SERVICE BULLETIN PP2023-11-2

PART # 0585023 - Obsolete

TEMP SWITCH

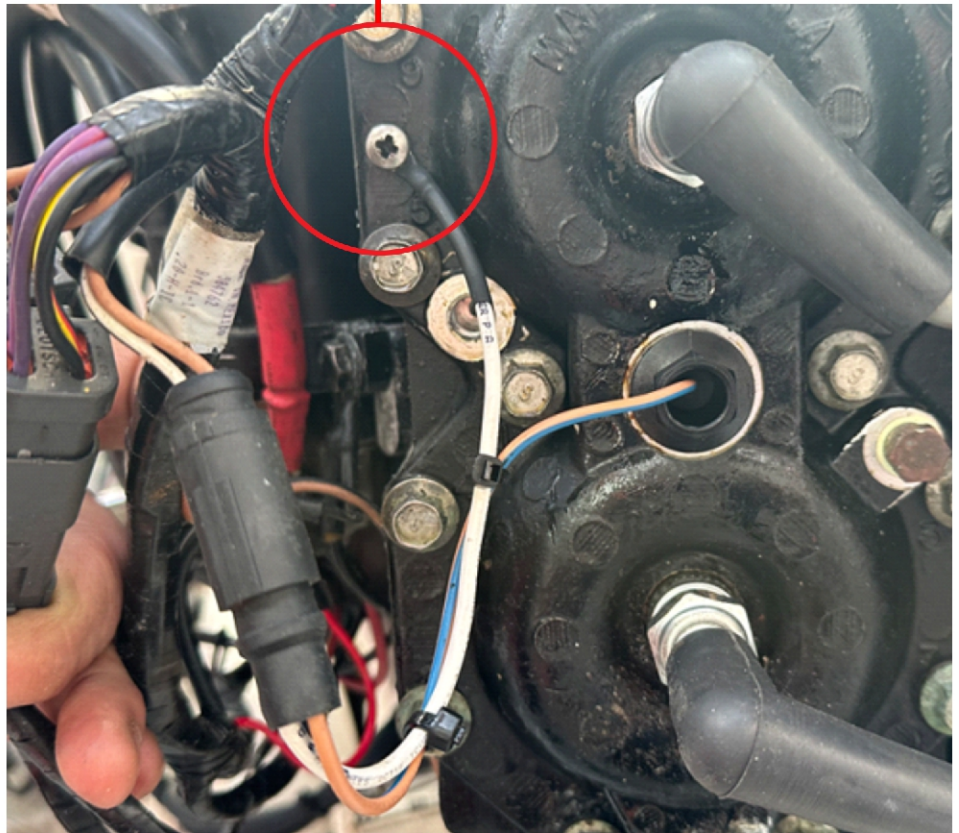
The Port Temp Switch (P/N- 0585023) has become obsolete
You can use the Starboard Temp Switch (P/N- 0585184) By grounding the white wire
See example photos

Cut the white wire off the 0585184 Temp Switch and put a ring terminal on it

0585185 – Substitute Temp Switch (After Modification – Installed)
